SERVICE BULLETIN

BULLETIN #: 04002

PRODUCT: CHP & WHP America Series

New Air Handler Condensate Pump System

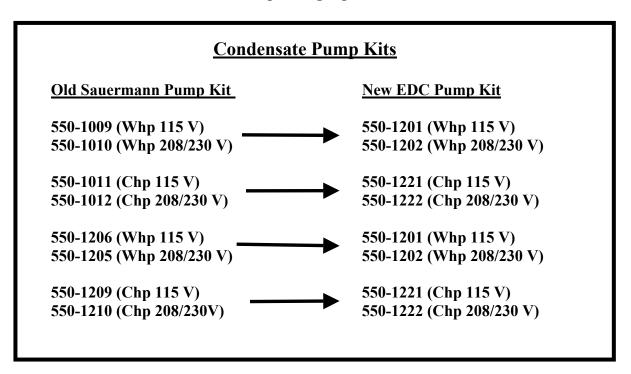
EMI is pleased to announce that we are expanding the use of the new EDC brand condensate pump system as the Sauermann pump will no longer be available.

The EDC condensate pump was released earlier this year for use on the WHP (Wall) air handlers and is now available for use on the CHP (Ceiling) air handlers.

The EDC condensate pump system is available in either 110 or 220 volts. New features include a plug and play method of installing this pump (Molex plug connection, no more time consuming hard wiring related to the control box), an inline filter, a relocated pump assembly for easy installation and maintenance and a quieter more powerful pump allowing for condensate lifts up to twenty feet.
